**ADDENDUM NO. 1
TO CONTRACT DOCUMENTS FOR THE
COYOTE WAREHOUSE PROJECT
Project No. 91234002**

Contract No. C0635

Notice is hereby given to Prospective Bidders that the Contract Documents are modified as hereinafter set forth.

ELEVATION **A** EAST
A-01 SCALE: 1/16" = 1'-0"

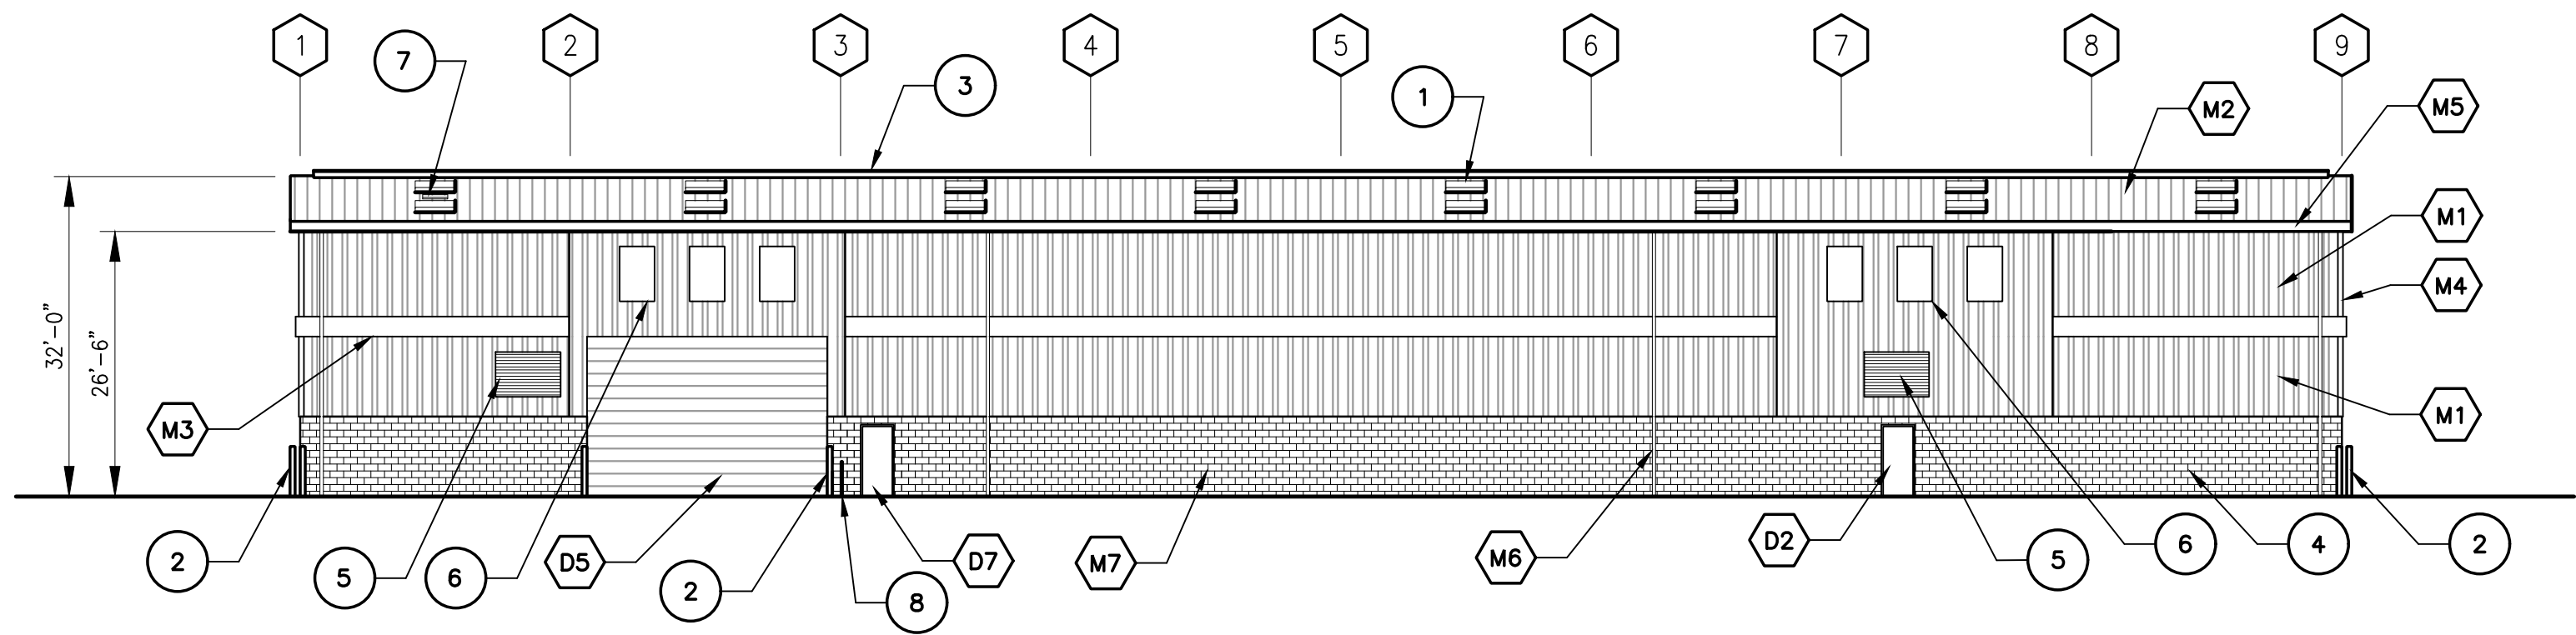
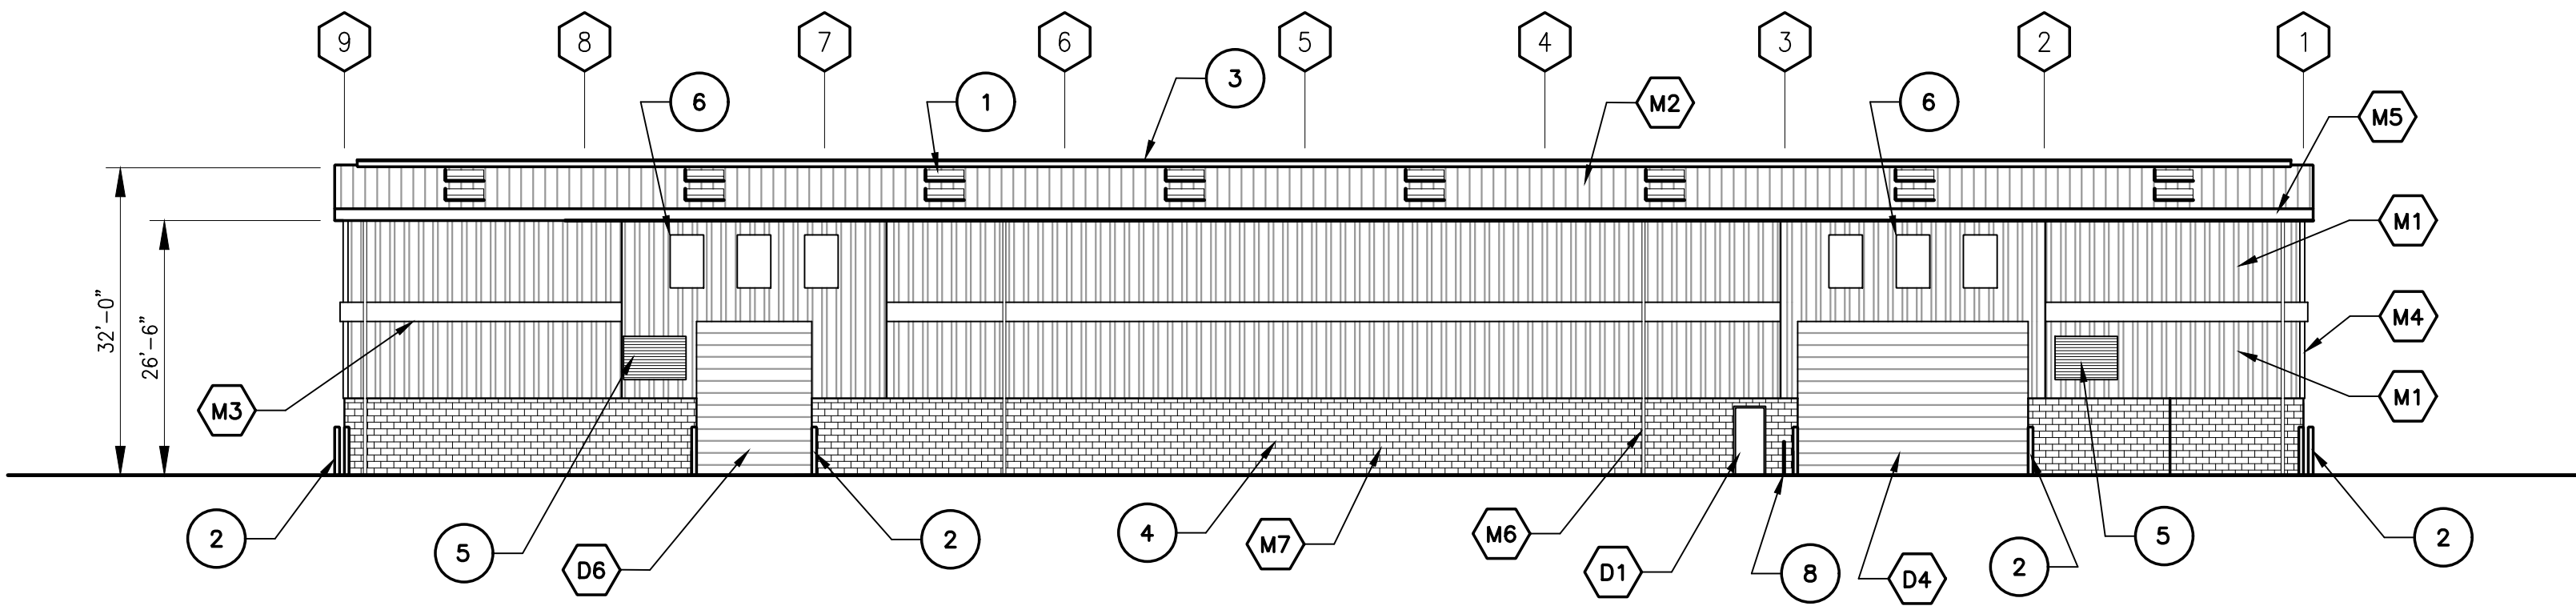
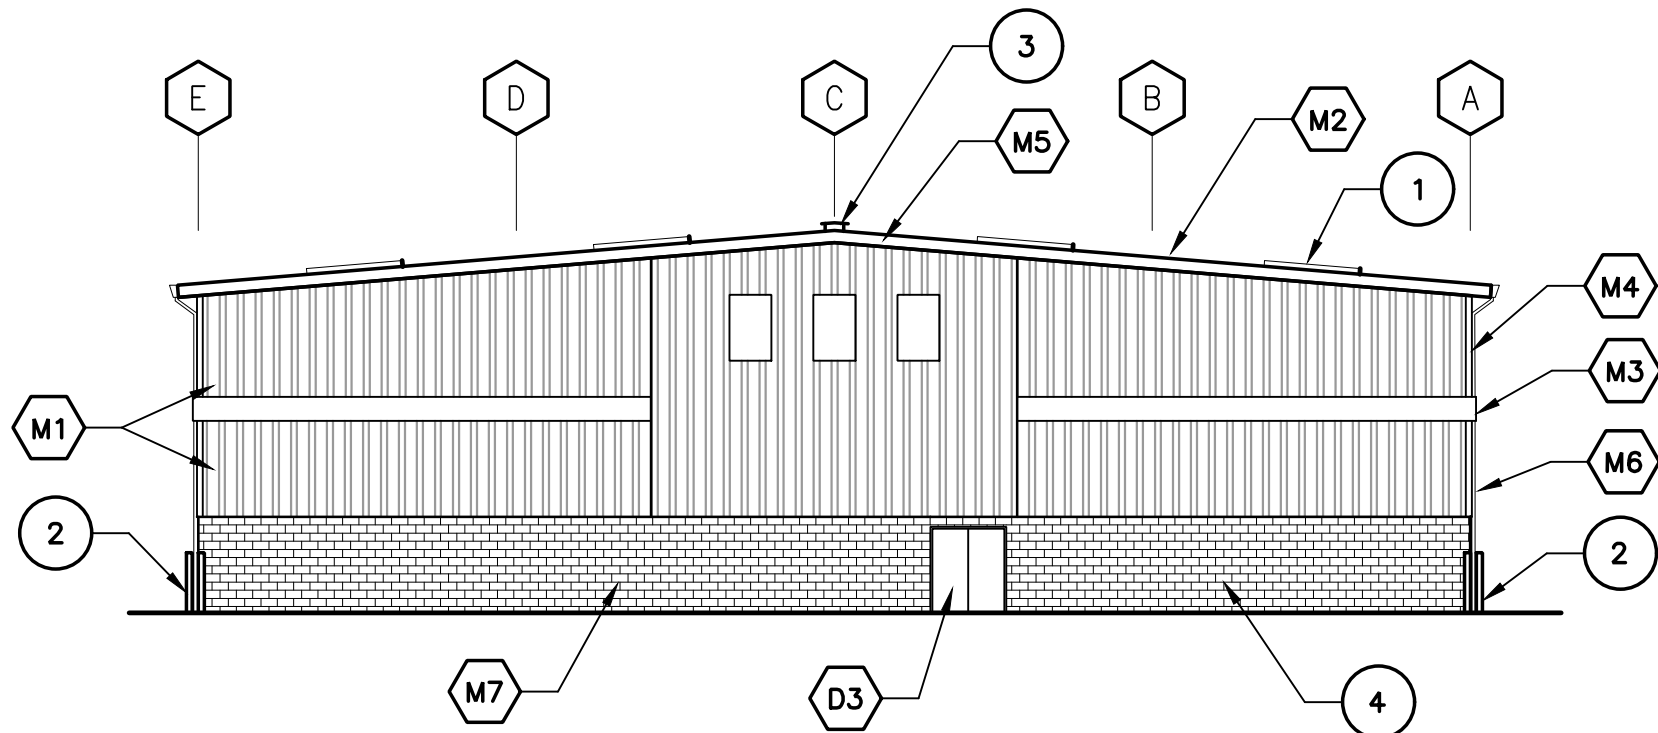
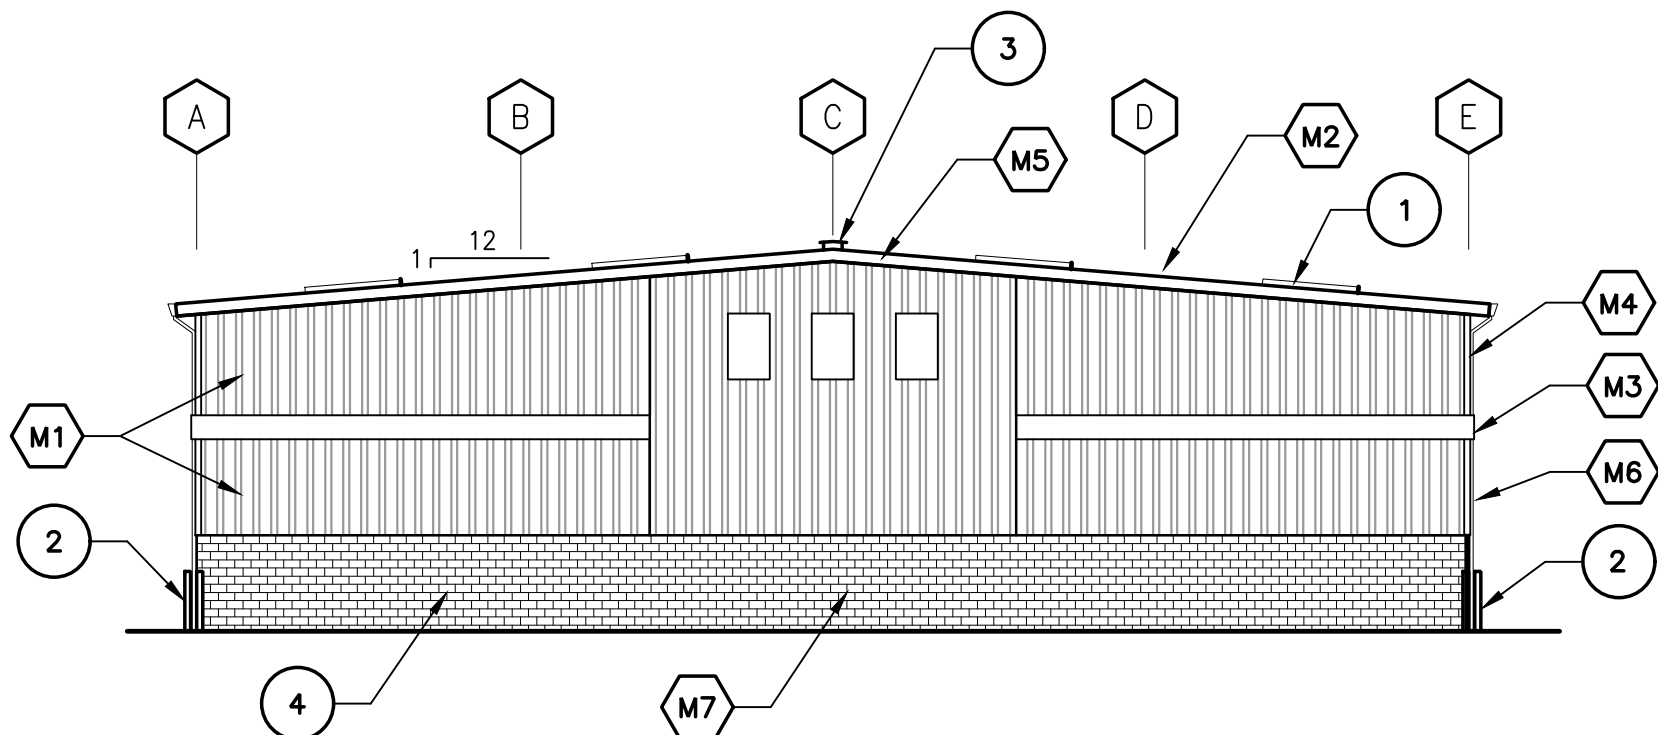
D1-21	A-02	<u>ADD</u> note 6 to only call for an opaque panel in lieu of Kalwall. See Attachment E.
D1-22	A-05	<u>ADD</u> material clarifications in the material finish schedule. See Attachment E.
D1-23	P0.1	<u>ADD</u> material clarifications in the material specifications chart. See Attachment E.
D1-24	P2.1	<u>REMOVE</u> splash block reference at downspouts. See Attachment E.
D1-25	E7.0	<u>ADD</u> photometric values at south building exterior light. See Attachment E.

NO.	QUESTION	RESPONSE
Q1-8.	Insulation: there is a specification for insulation but none shown on the plans. I would not recommend rigid. Please tell us where and the R-value.	See revised Sheet A-05. Provide insulation with R-19 min. with vapor barrier.
Q1-9.	In Appendix G, The City of Morgan Hill lists that the Storm Water Control Plan is under review. What is the status of this review?	The City has submitted their review comments and are provided in Attachment F of this Addendum
Q1-10	Our Skylight supplier is stating that the specs call out for a structural glass skylight which will be very expensive, especially for a warehouse. You would be better off going with translucent panels that match the panel configuration. Or a standard dome skylight. The same thing with the Kylwall. It is very expensive and harder to make weather tight as apposed to translucent panels.	With respect to the skylights please bid the project per the specifications and drawings. The wall panels have been revised to eliminate the requirement for Kalwall per revised Sheet A-02.
